MR 140

SERVICE BULLETIN

MR/140 HUMM REDUCTION

MR/140 REVERB PAN MOUNTING MODIFICATION
 PER ECO NO. 212-83

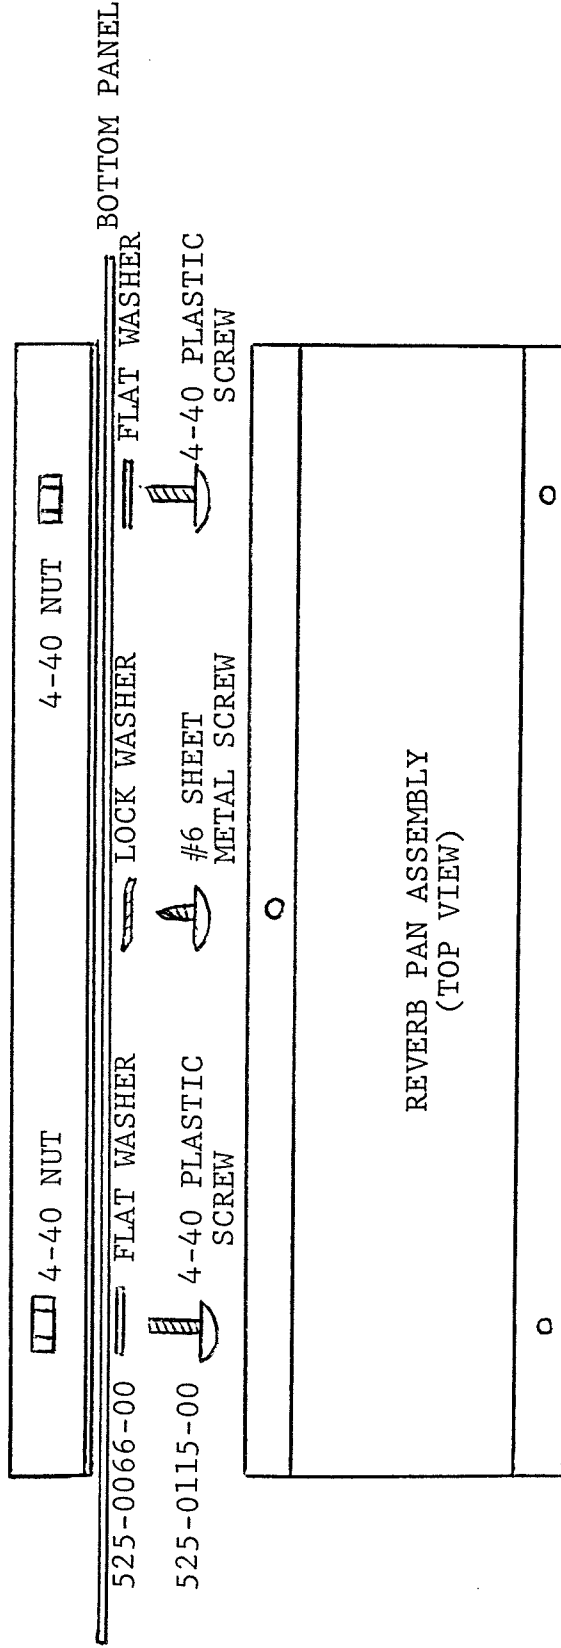
WE HAVE FOUND SOME MR/140 REVERB UNITS CAN PRODUCE A SUBSTANTIAL 120 CYCLE HUM WHENEVER THE WET SIGNAL IS USED. INVESTIGATION OF THIS PROBLEM HAS FOUND A MAGNETIC FIELD CIRCULATING THROUGHOUT THE ENTIRE CHASSIS. TO CURE THE PROBLEM IT IS NECESSARY TO OPEN THIS MAGNETIC PATH.

1. REMOVE THE TOP AND BOTTOM PANELS FROM THE CHASSIS.
2. EXAMINE THE REVERB PAN AND FOAM PAD ON THE BOTTOM PANEL. THE PAN SHOULD BE LOCATED ON THE PAD SO THAT NO PART OF THE PAN IS TOUCHING THE METAL BOTTOM PANEL (SCREWS ARE THE ONLY CONTACT). ADDITIONAL INSULATION MAY BE REQUIRED (THIN CARDBOARD, FISH PAPER).
3. CUT 3/8" WIDE STRIPS TO LAY ON THE TOP AND BOTTOM SIDE OF THE CHASSIS WRAP.
4. RE-INSTALL THE TOP AND BOTTOM COVERS WITH THE MOUNTING SCREWS BEING THE ONLY METAL CONTACT TO THE CHASSIS WRAP.

REPLACE 2 OF THE PAN MOUNTING SCREWS WITH PLASTIC SCREWS, PART NUMBER 525-0115-00, TO BREAK A MAGNETIC CIRCUIT PATH IN THE PAN HOUSING.
